Service Bulletin

SUBJECT: Service Update for Inventory and Customer Vehicles
Jack Collapse
Expires with Base Warranty

MODELS: 2013-2015 Chevrolet Tracker, Trax

4335972

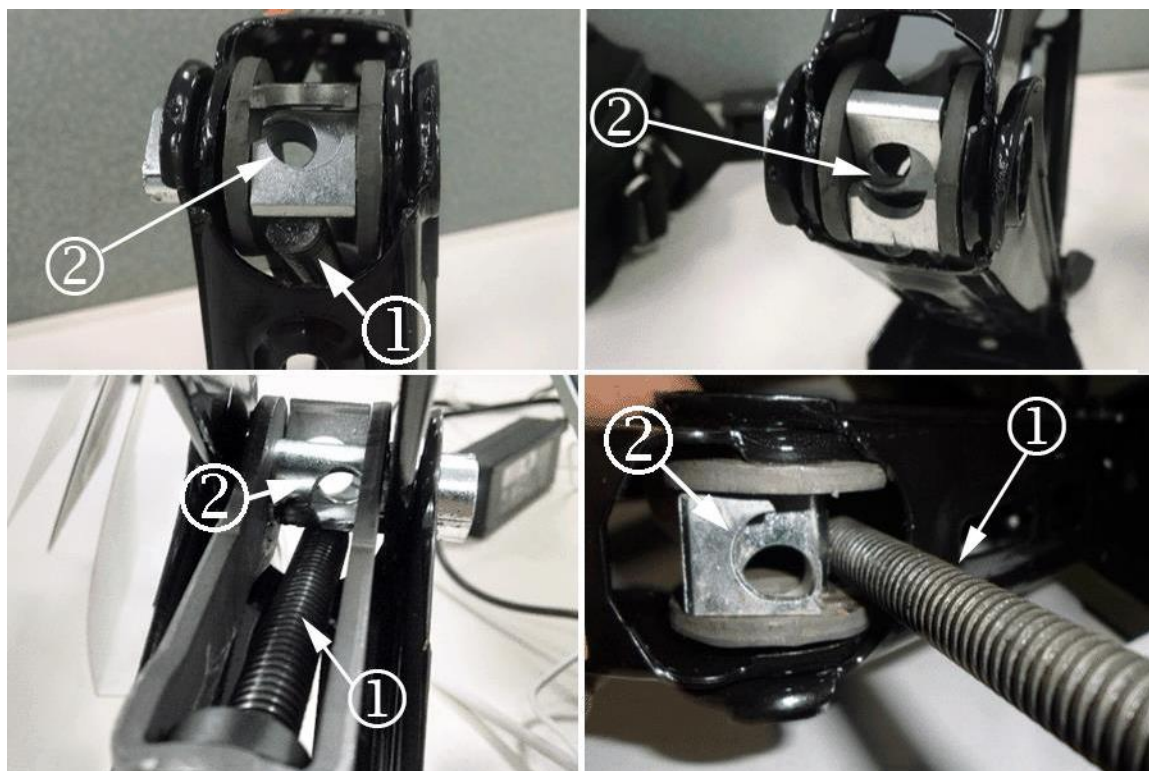
4. Carefully inspect the operation of the jack and verify the alignment of the jack lead screw and jack lead screw guide. Refer to the example of the misaligned jack lead screw (1) and jack lead screw guide (2) shown above.
 - If the jack operates normally, and the jack lead screw is in the guide and is not damaged, no further action is required. Install the jack to the tool stowage container, install the load floor stowage compartment cover, and close the liftgate.
 - If the jack lead screw or the jack lead screw guide is misaligned or damaged, the jack must be replaced.
